TITLE: QUARTER PANEL SECTIONING  
SECTION: EXTERIOR BULLETIN # 183  
MODELS: 2013- SCION FR-S  
DATE: DECEMBER 2012

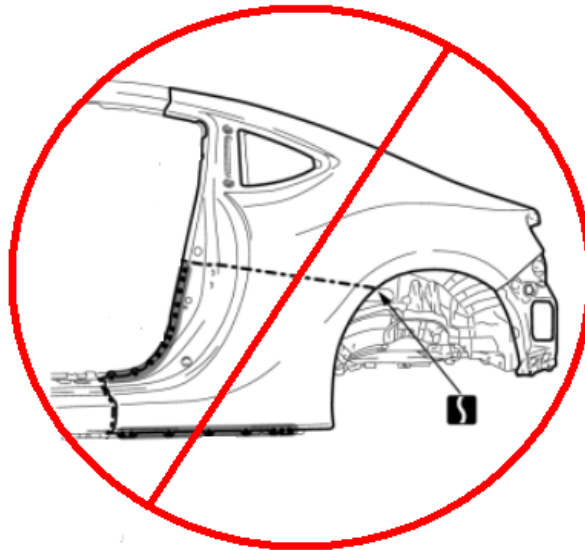
The 'Quarter Panel Sectioning' procedure shown below referred to as "Cut-P" "Small Section", **has been determined to be an unacceptable repair procedure** by the conditions provided below.

**NOTE:** The P-Cut Small Section replacement procedure may lead to one or more of the following unacceptable conditions:

- Excessive panel warping
- Extensive corrosive hot-spots from butt welding
- Excessive use of body filler materials
- Reduced repair quality leading to a detectable repair
